Western Power Trading Forum Comments on Flexible Resource Adequacy Criteria and Must-Offer Obligation Phase Two Revised Straw Proposal

Carrie Bentley, Resero Consulting for WPTF, 916-217-1571, cbentley@resero.com

May 22, 2017

Figure 1: Allowed self-scheduled capacity under current RA rules in 2016

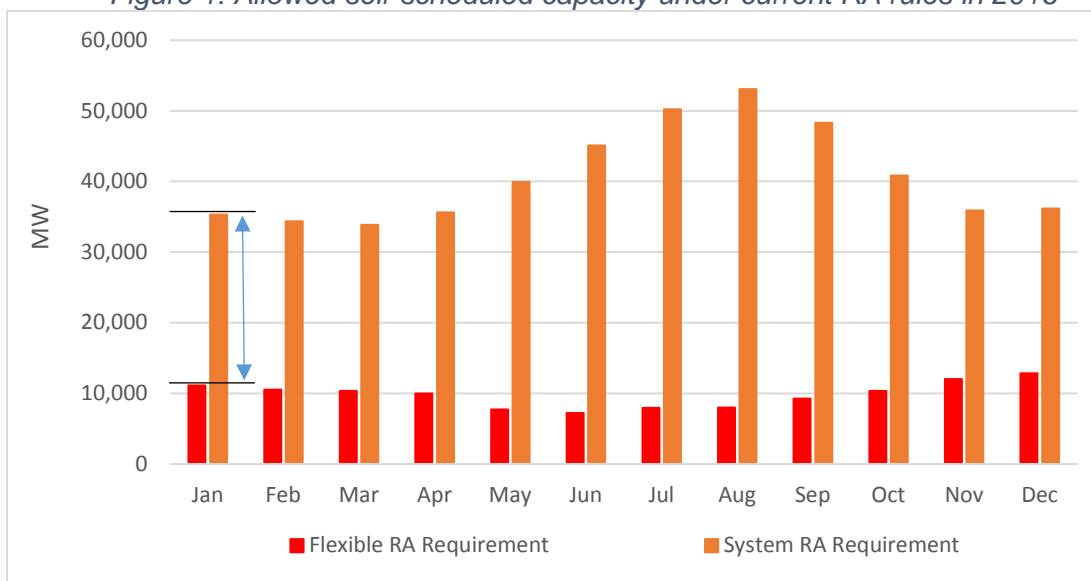
Figure 1 shows the amount of RA capacity that may be self-scheduled under the current RA rules. The orange bars show the 2016 system RA requirement by month and the red bars show the 2016 flexible RA requirement by month. Because flexible capacity also qualifies as system capacity, typically every MW increase in the flexible requirement directly decreases the amount of RA capacity that may be self-scheduled under ISO rules. This is because flexible capacity *must* be economically offered into the energy market whereas system capacity *may* be self-scheduled into the energy market. The range illustrated in Figure 1 by the blue arrow therefore shows the amount of RA capacity that is inherently allowed to be self-scheduled under ISO RA rules in January 2016. This is approximately 24,000 MW.

Under a 50% renewable goal, it is reasonable to question why the ISO would continue to explicitly allow 24,000 MW of inflexible capacity. If, in 2018, anywhere near the amount of system capacity required began to self-schedule, the ISO would not be able to commit and de-commit resources exclusively using energy bids and instead would have to begin curtailing renewables. In 2018, the ISO expects the minimum net load to be around 11,000 MW, which was already surpassed in May with a record minimum net load of 8,500 MW, yet explicitly will allow self-scheduling at a much higher level. Because self-scheduled capacity cannot represent the relative willingness to be cut, the ISO must create administrative, out-of-market rules, to determine which resources are cut. This decreases efficiency- and at a high level of intervention - risks reliable grid operations. WPTF does not believe that all 24,000 MW would actually self-schedule, and instead simply questions the efficiency of continuing with a system that allows such a high level of self-scheduling into the future.

Figure 2: Flexible RA enhancement using 2016 illustrative data

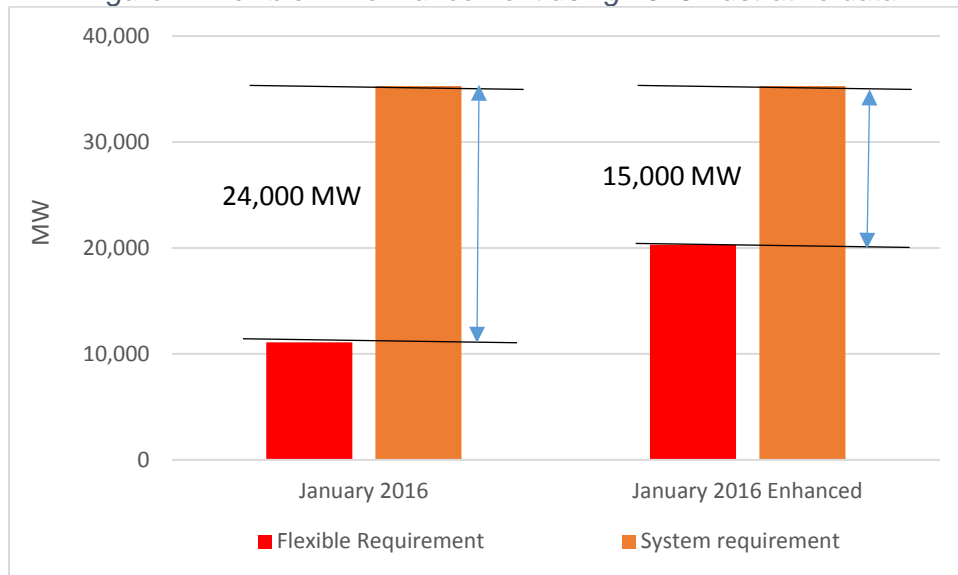
Figure 2 illustrates how this could be done using January 2016 flexible and system RA requirements, assuming a minimum net-load of 15,000 MW. In Figure 2, the orange bars show the system RA requirement and the red bars show the current flexible RA requirement and the enhanced flexible RA requirement. Under the enhanced approach, the flexible requirement increases to the point that the ISO can allow all system RA to self-schedule (up to 15,000 MW) and still being able to economically commit and dispatch the remaining RA capacity through the energy market optimization. This is because the remaining RA capacity must be flexible capacity and therefore has the associated economic must-offer obligation.

Again, this is for thought-provoking purposes, thus proposing an extreme case. In reality the ISO could exclude some level of renewable capacity from the minimum net load calculation to account for economic curtailment and could make some adjustments in both directions for inflexible Pmin capacity from flexible resources and system capacity.

Figure 5: 2016 current and enhanced flexible RA requirements compared to available flexible capacity

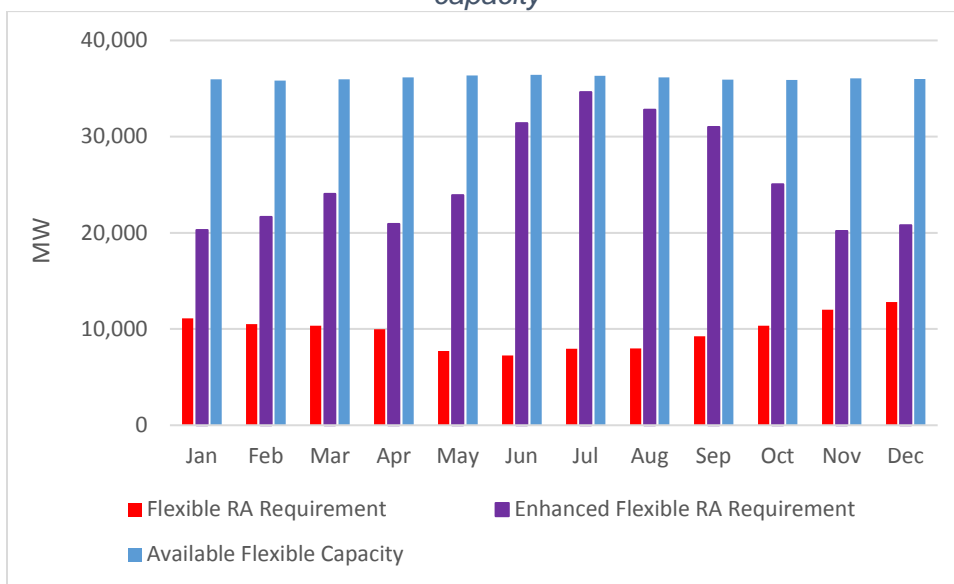
Figure 5 shows the current and enhanced requirement for 2016 compared to the total qualified flexible RA in 2016.¹² LSEs would be able to meet the enhanced requirement even without accounting for new resources being able to qualify to meet the flexible RA requirement (imports, exports, storage charging, etc.),.

Figure 6: Average hourly self-scheduled generation compared to Load

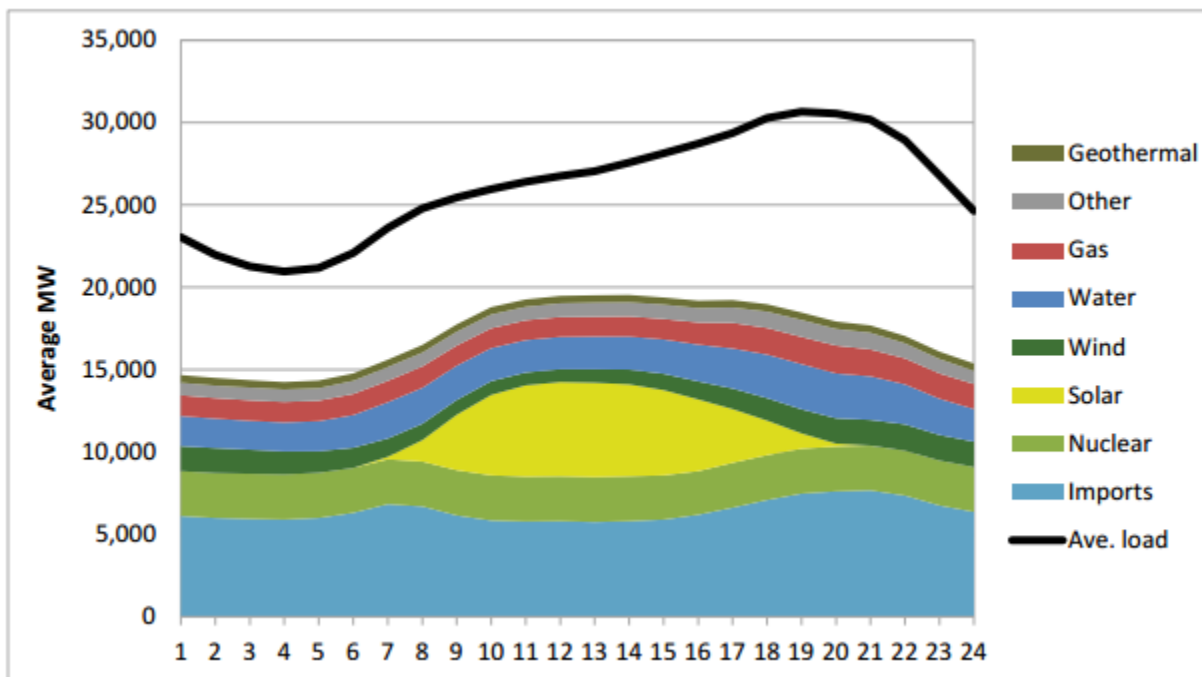
Figure 6 below is Figure 4.20 of the 2016 Department of Market Monitoring Annual Report. It shows the average amount of supply being self-scheduled into the market. Notably, by far the biggest amount of self-scheduled capacity comes from imports. A category of resource that neither the current nor the proposed short-term solution addresses.
